Product Change Notification / SYST-02AMFX809

ATmega48A/PA/88A/PA/168A/PA/328/P Silicon Errata and Data Sheet Clarification

Silicon Errata and Data Sheet Clarifications

ATmega48A/PA/88A/PA/168A/PA/328/P

3.3.1 32M1-A

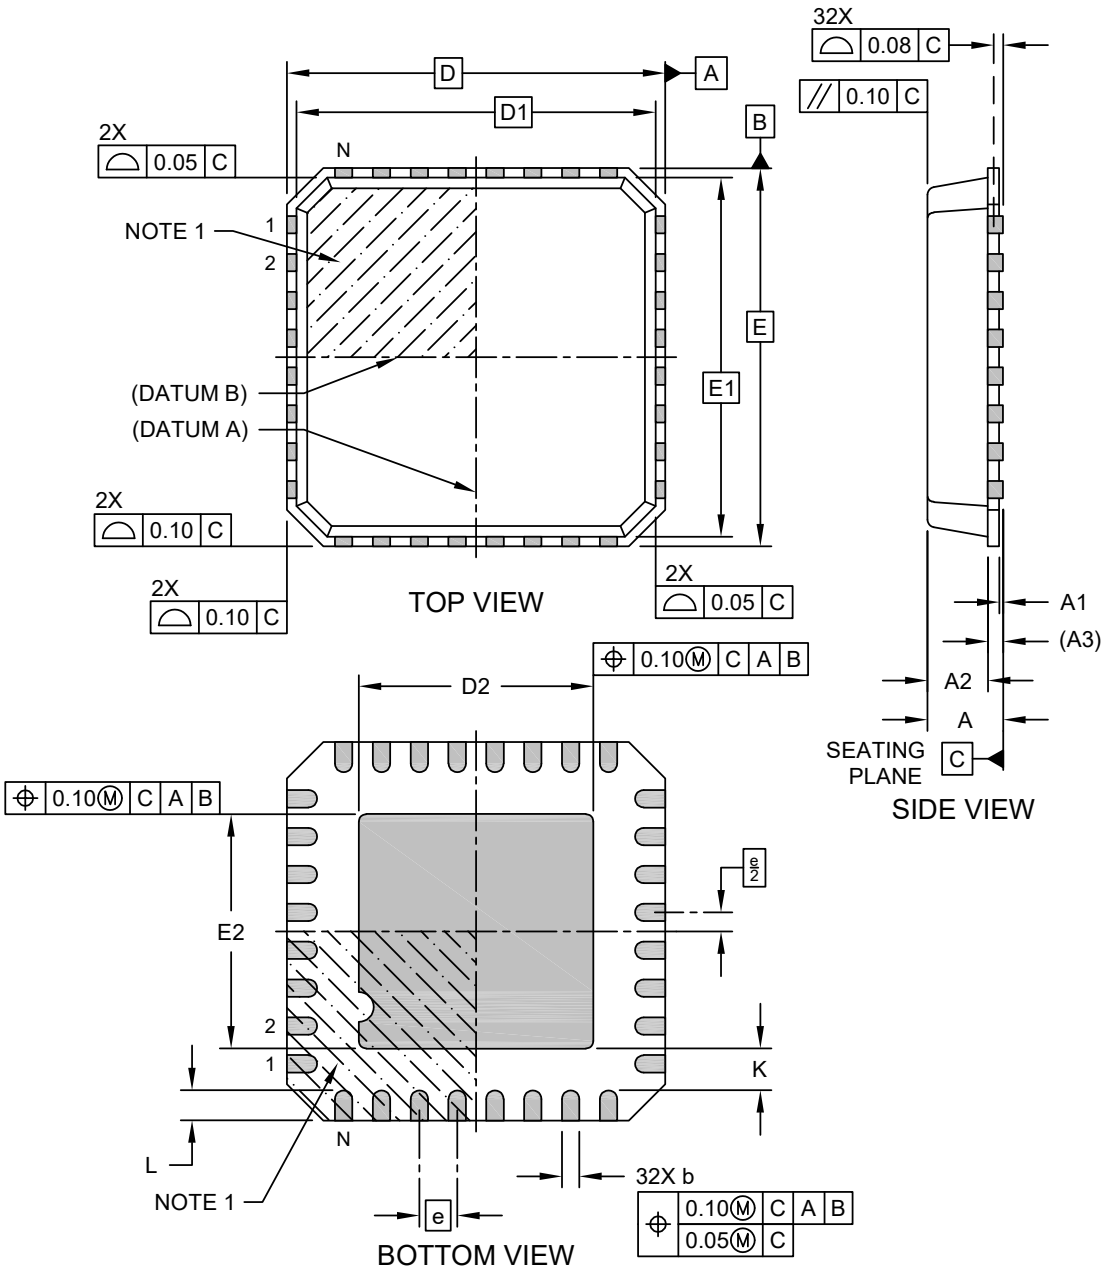
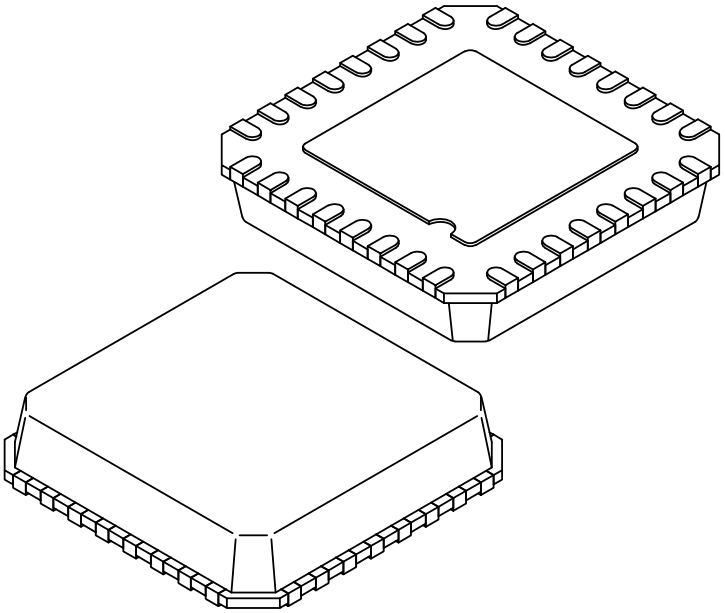
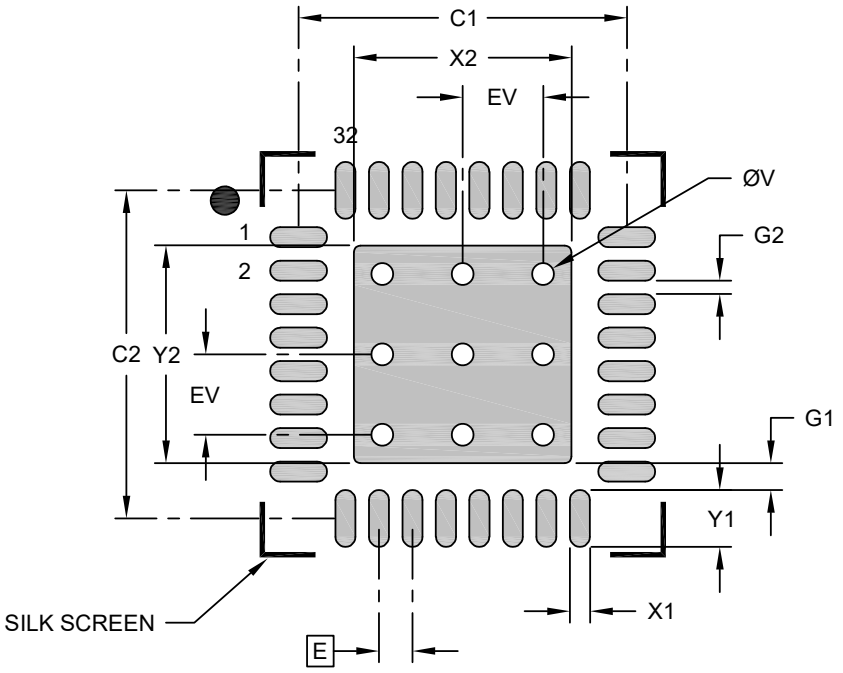
1. **This package type can be delivered with two different styles with reference numbers 'C04-21400' (punched) and 'C04-21395' (sawn) as shown in section 3.2.1 - 32M1-A. For PCB layouts, it is recommended to take both *recommended land patterns* into consideration.**

A clarification about the other package style available for package type 32M1-A has been added to the 32M1-A section.

Microchip Technology Drawing C04-21395-UBB Rev C Sheet 1 of 2

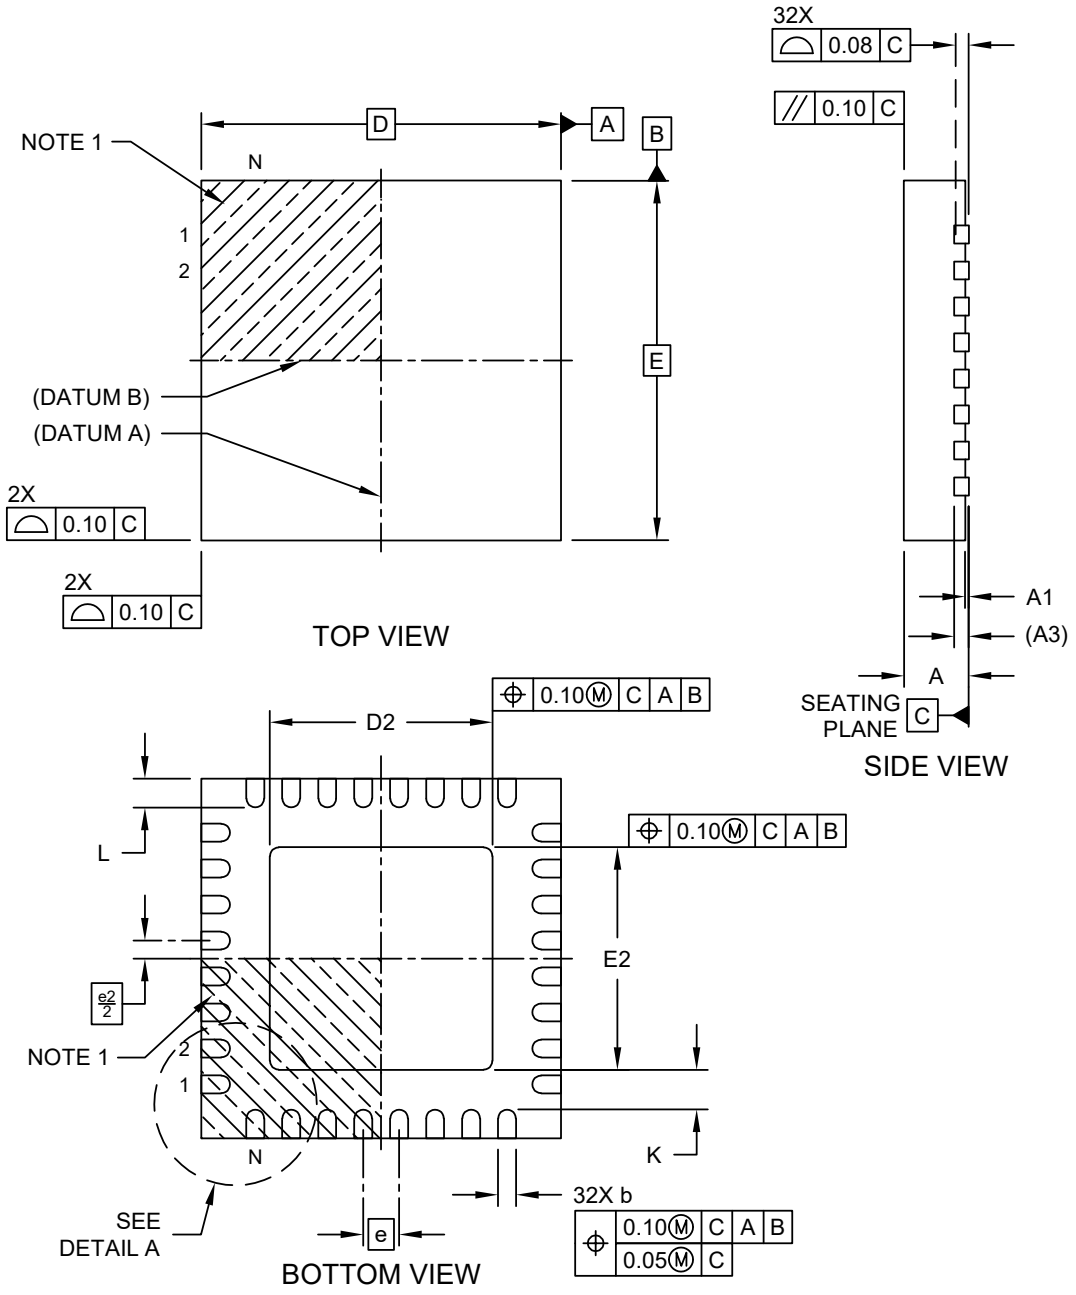
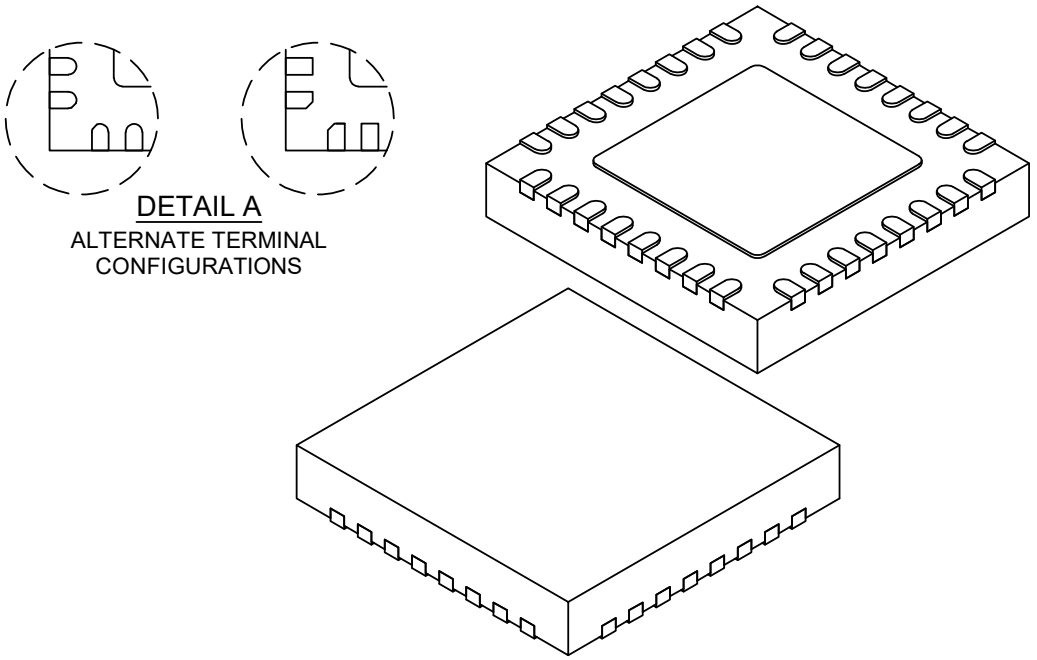
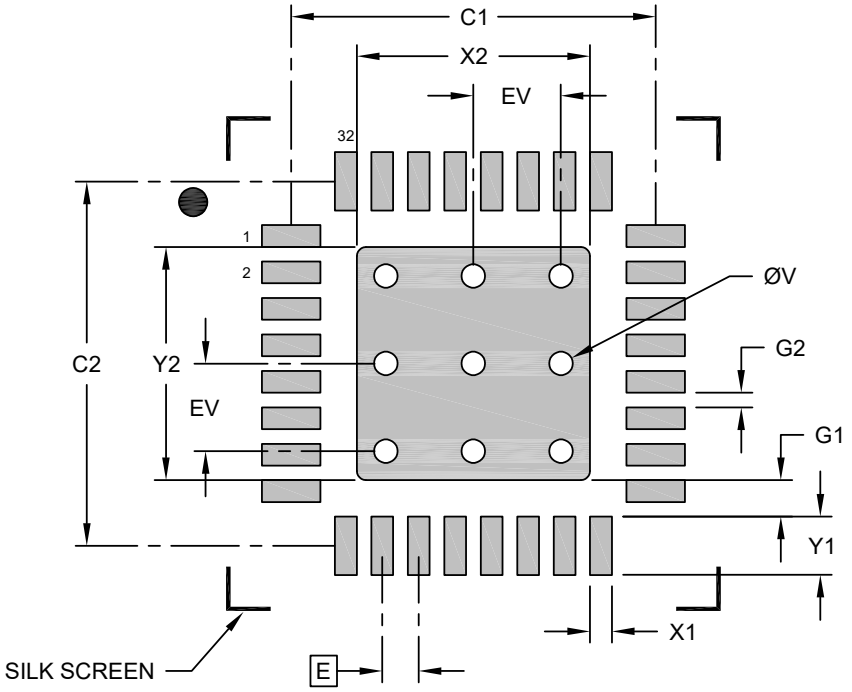
- A note to the 32M1-A row was added informing that the package type can be delivered in two different styles
